ADDENDA / ERRATA

To Bridge Design Specifications Users:

Recently, we were made aware of some revisions that need to be applied to the California Amendments to the AASHTO LRFD Bridge Design Specifications – 8th Edition. The most recent revisions are shown in **bold** in the table below. Please replace the previous version of the California Amendments with the version appended herein, which incorporates all errata and addenda to date.

California Amendments to the AASHTO LRFD Bridge Design Specifications (2017 Eighth Edition)

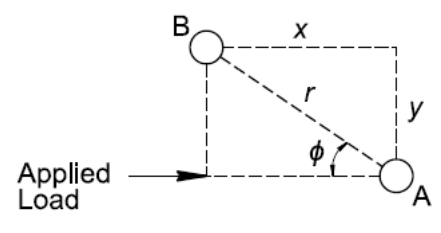
Page	Existing Text	Revised Text
Section 10 Cont. 10-91C		<u>(ii) Determine group pile efficiency factor for line-by-line effect</u> The group pile efficiency factor for the line-by-line effect for the leading pile shall be calculated as. $\beta_{\beta l} = 0.7 \left(\frac{s}{B} \right)^{0.26} \quad \text{for } 1 \leq \frac{s}{B} < 4.0$ $\beta_{\beta l} = 1 \quad \text{for } \frac{s}{B} \geq 4.0$ (10.7.2.4-2) where $\beta_{\beta l}$ = group pile efficiency factor for line-by-line effect for the leading pile (dim) s = center to center pile spacing between the pile for which $\beta_{\beta l}$ is determined and any other pile (ft) The group pile efficiency factor for the line-by-line effect for the trailing pile shall be calculated as. $\beta_{\beta t} = 0.48 \left(\frac{s}{B} \right)^{0.38} \quad \text{for } 1 \leq \frac{s}{B} < 7.0$ $\beta_{\beta t} = 1 \quad \text{for } \frac{s}{B} \geq 7.0$ (10.7.2.4-3) where $\beta_{\beta t}$ = group pile efficiency factor for line-by-line effect for the trailing pile (dim) s = center to center pile spacing between the pile for which $\beta_{\beta t}$ is determined and any other pile (ft)  <u>Figure 10.7.2.4-3 Line-by-Line Effect</u>

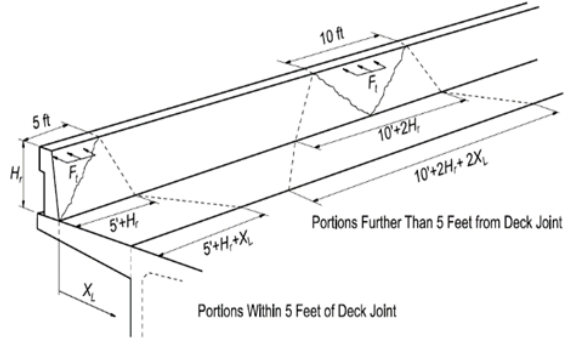
Page	Existing Text	Revised Text
Section 13		
13-25A Cont.		<u>The flexural resistance of the deck overhang shall be determined in accordance with Section 5, with the following additional requirements for deck overhangs on existing bridges:</u> • <u>Both top and bottom transverse deck reinforcement shall be considered.</u> • <u>The expected yield strength of the existing deck overhang reinforcement and the expected concrete compressive strength of the deck overhang shall be used in lieu of the specified minimum yield strength and specified concrete compressive strength, respectively.</u>  Figure A13.4.2-1 – Force Effects on Deck Overhang Due to Railing Collision Force”
13-25A	CA13.4.2 reads: “If the deck overhang capacity is less than that specified, the yield line failure mechanism for the parapet may not develop as shown in Figure CA13.3.1-1, and Eqs. A13.3.1-1 and A13.3.1-2 will not be correct. The crash testing program is oriented toward survival, not necessarily the identification of the ultimate strength of the railing system. This could produce a railing system that is significantly overdesigned, leading to the possibility that the deck overhang is also overdesigned.”	Delete the entire commentary CA13.4.2 and replace with the following: <u>“Concrete Barrier Type 836 and Concrete Barrier Type 842 are examples of solid concrete parapet railings. Concrete Barrier Type 85 and California ST-75 Bridge Rail are examples of post-and-beam railings with continuous concrete curbs.</u> <u>The effective lengths of the deck overhang used to resist the railing collision force are illustrated in Figure CA13.4.2-1. The effective lengths were determined based on the results of static nonlinear finite element analyses.</u>

Figure C2.6.4.4.2-1 Spread Footing Location

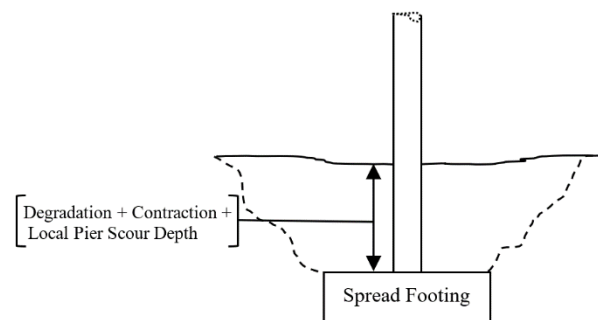
Add the following after the 3rd paragraph:

Total scour is the cumulative sum of contraction, degradation, and local scour. Figure C2.6.4.4.2-1 shows a typical spread footing foundation.

Figure C2.6.4.4.2-2 Deep Foundation Location

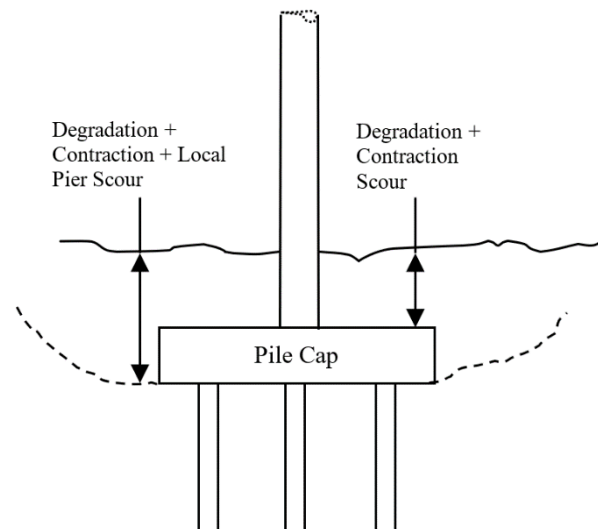
Add the following after the 4th paragraph:

Foundations should be designed to withstand the conditions of scour. In general, this will result in deep foundations. Figure C2.6.4.4.2-2 shows a typical deep foundation.

Figure C5.5.4.2-1—Variation of ϕ with Net Tensile Strain ϵ_t for Nonprestressed and Prestressed Sections

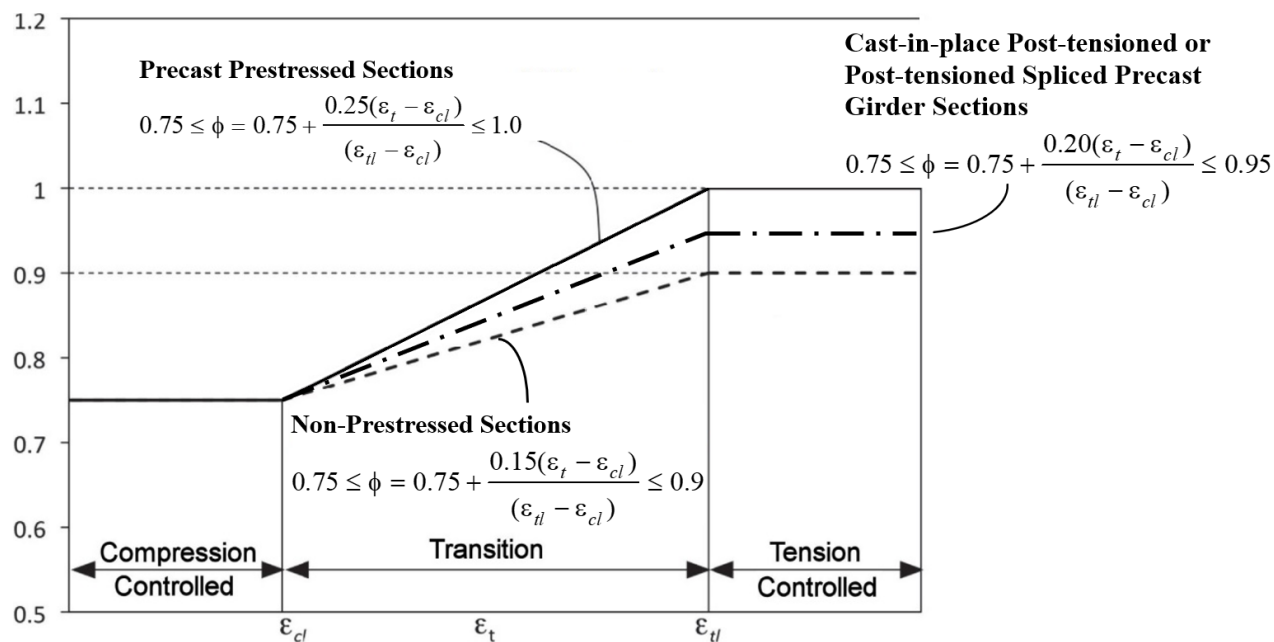
Replace Figure C5.5.4.2-1 with the following:

Figure 10.6.3.1.2e-2—Modified Bearing Factor for Two-Layer Cohesive Soil with Weaker Soil Overlying Stronger Soil (EPRI, 1983)

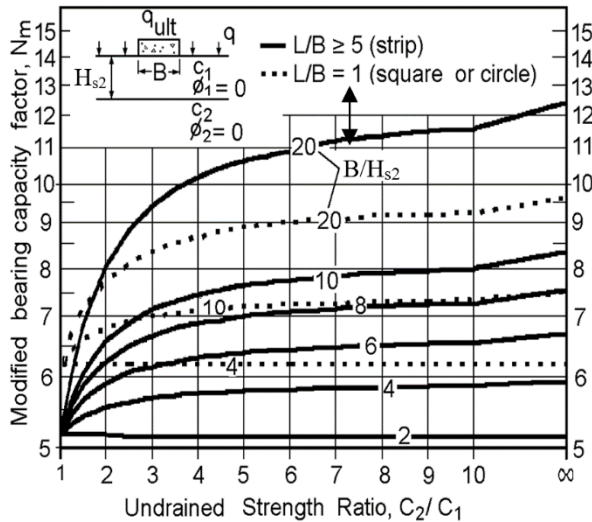
Replace H with H_{s2} in Figure 10.6.3.1.2e-2,

Figure C10.7.3.8.2-1—Davisson's Method for Load Test Interpretation (Cheney and Chassie, 2000, modified after Davisson, 1972).

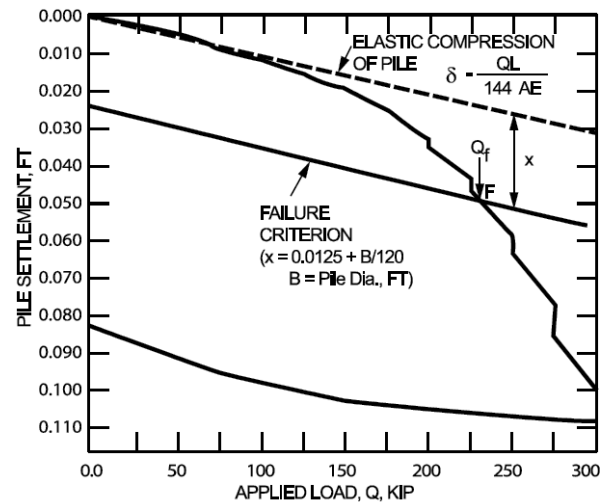
Replace Figure C10.7.3.8.2-1 with the following:

Figure C11.9.5.1-3—Calculation of Anchor Loads and Pile Embedment Depth for a) One-Level Wall and b) Multilevel Wall

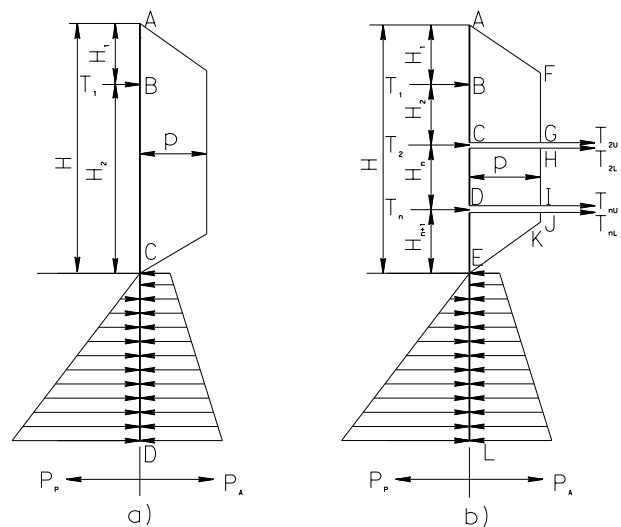
Add the following figure after Figure C11.9.5.1-2:

Figure A11.3.1-1—Mononobe-Okabe Method Force Diagrams

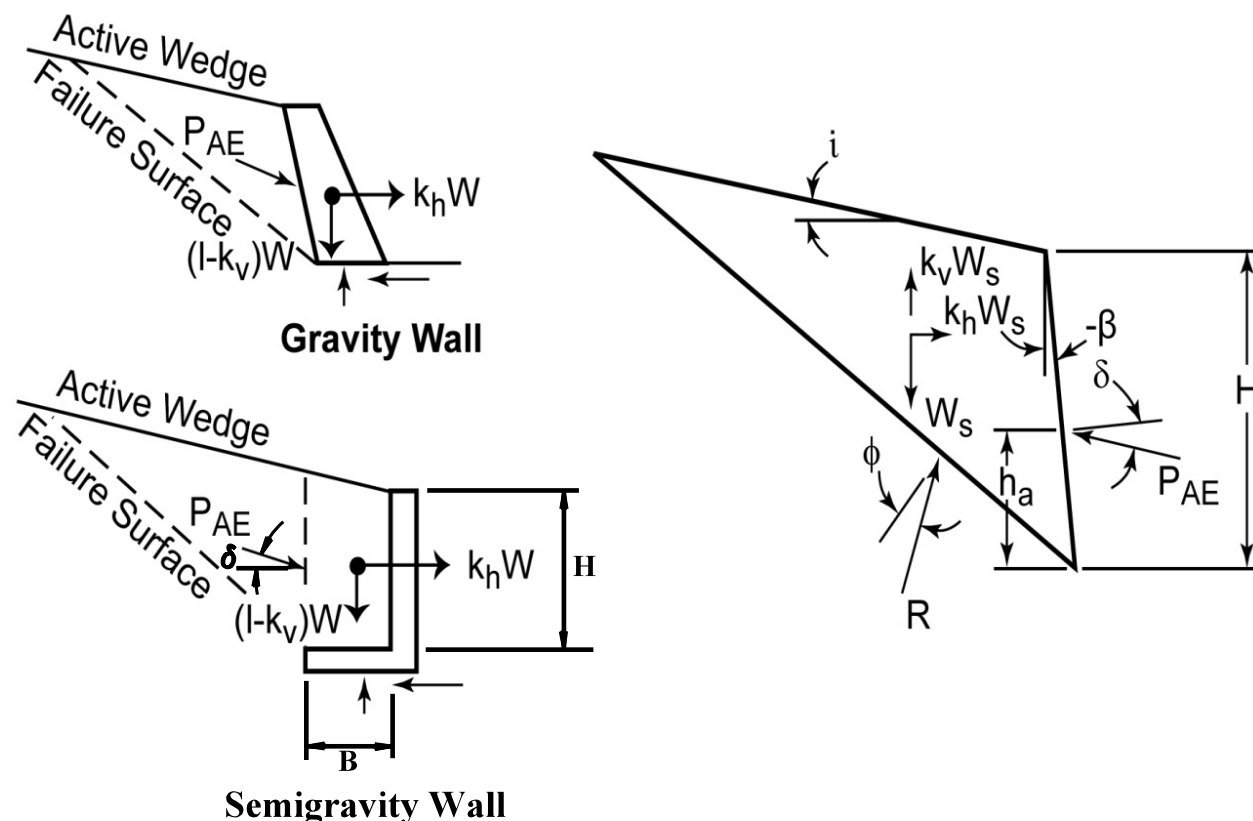
Replace Figure A11.3.1-1 with the following:
